PART B PANEL SUBMISSION

GREATER GEELONG PLANNING SCHEME AMENDMENT C391ggee & PERMIT APPLICATION No. PP-39-2019

73-85 Ash Road to 143-155 Ash Road, LEOPOLD

Part B Submission to the Independent Panel

Figure 5 – Council response to revised layout plan

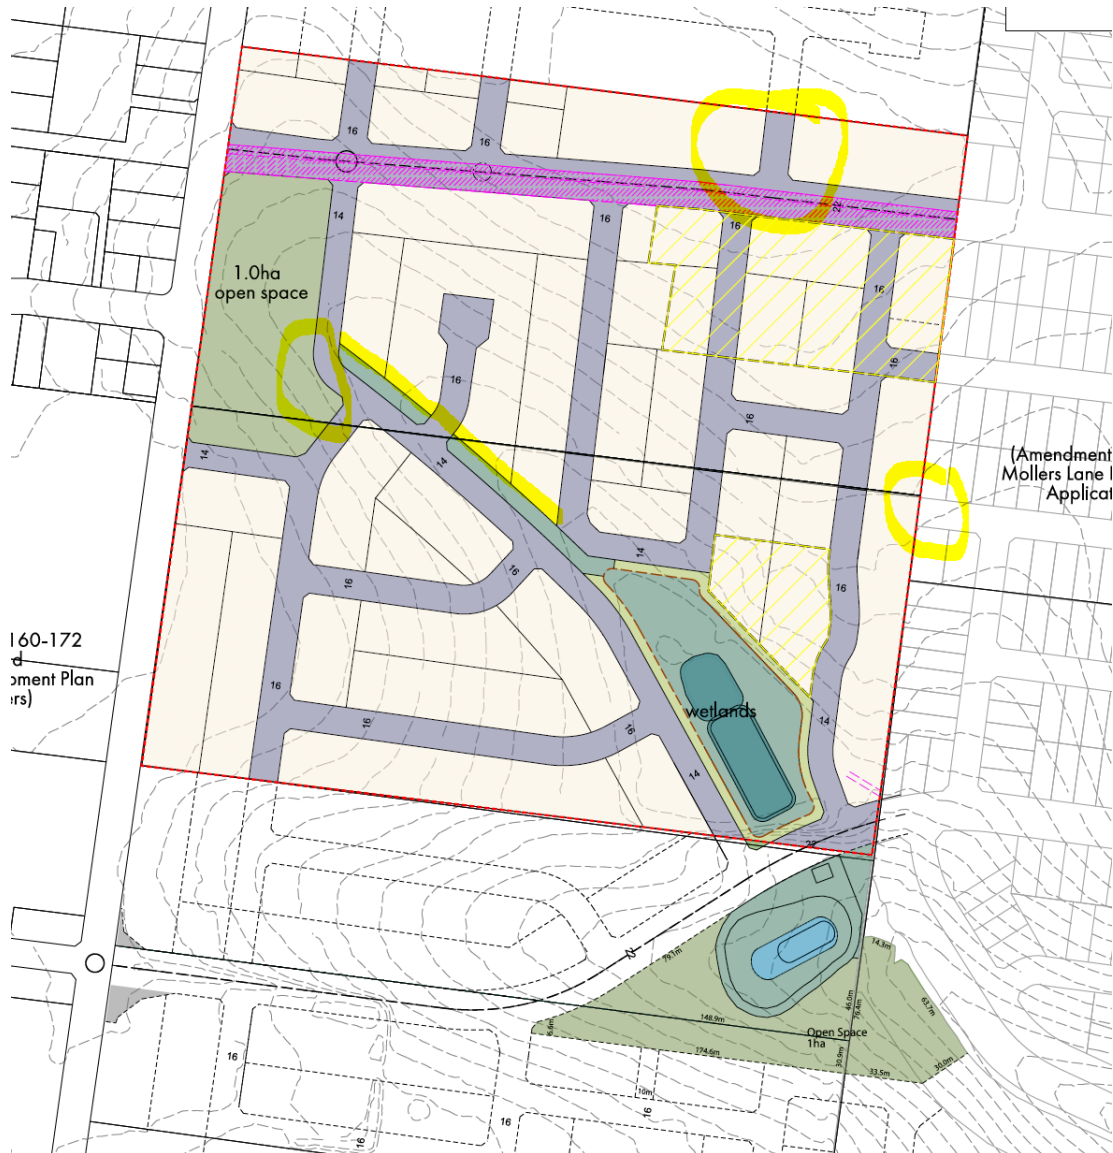
125. The revised plan is generally supported but there are some points that require adjustment (some of these are highlighted on **Figure 5**):
- The site lines for pedestrians/cyclists crossing from around the south eastern edge of the proposed 1ha park need some further work. In Council's submission response we had commented that the apex of the bend in the road may require some smoothing so that crossing on a road bend is avoided.

- There is not complete integration with the Mollers Lane area on the eastern side. There is a road connection planned from Mollers Lane into the area that shows no commensurate road in the revised plan – this needs to be addressed and we note the expert evidence of Mr Young on this being resolved.

- At the northern end of the subdivision plan, the eastern most north-south road connection to the property at 73-85 Ash Road should be moved eastward, closer to Mollers Lane. This will remove a potential long court bowl on that property.

- The plan needs to demonstrate that all services can be accommodated within the road verges adjacent to the open space.
 - Sediment drying areas needs to be provided in encumbered open space outside of the Q100 extent.

- Consideration required to avoid a long length of side, paling fences along the northern side of the encumbered drainage reserve/corridor – this could be addressed through unit development access from the adjoining north-south side minor roads.

- Clarification is required on the sub-terranean pipe works in the proposed 1ha park.

Figure 6 – Extract of figure 5-14 from Traffic Evidence

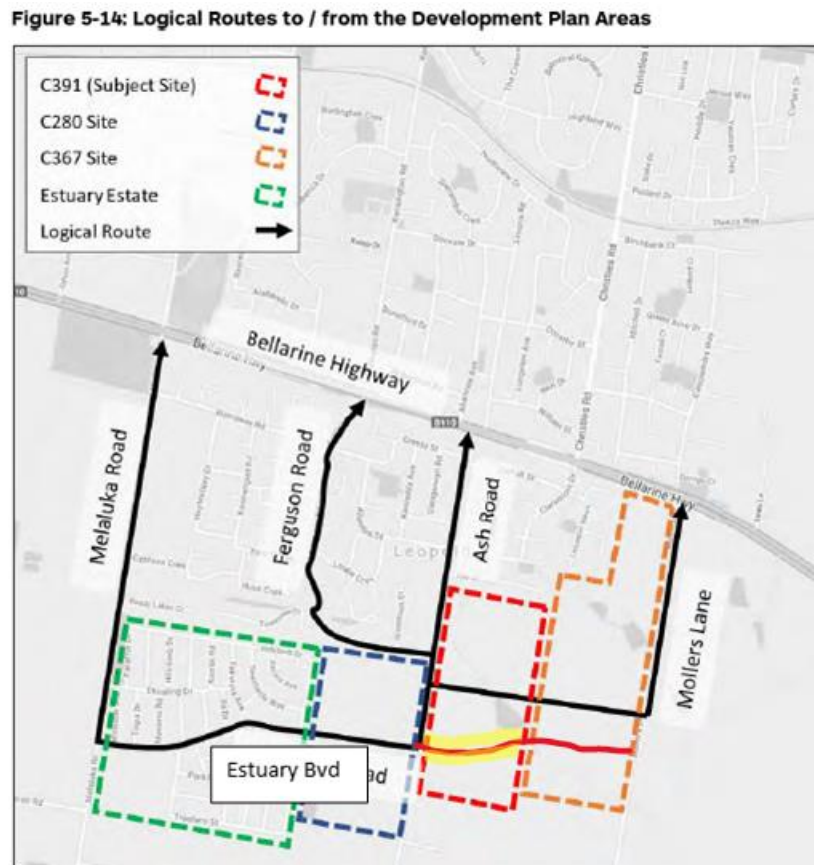
146. We note that the evidence concludes that Ash Road and the broader road network (subject to the extension to the right turn lane on the Highway), can accommodate the traffic to be generated by up to 330 dwellings in the amendment area.
147. We note that the Estuary Boulevard extension through the subject site and the Mollers Lane sites has not been shown in Fig. 5-14 and the following plans of the evidence. This is highlighted in Figure 6.

148. This eventual southerly connection will allow for a direct route between Mollers Lane and Melaluka Road and attract some traffic and will have a higher order collector road function. Our traffic engineering advice considers that there will be more traffic using this road than the east-west lower order road to its north. The evidence needed to discuss these impacts in the traffic distribution analysis.
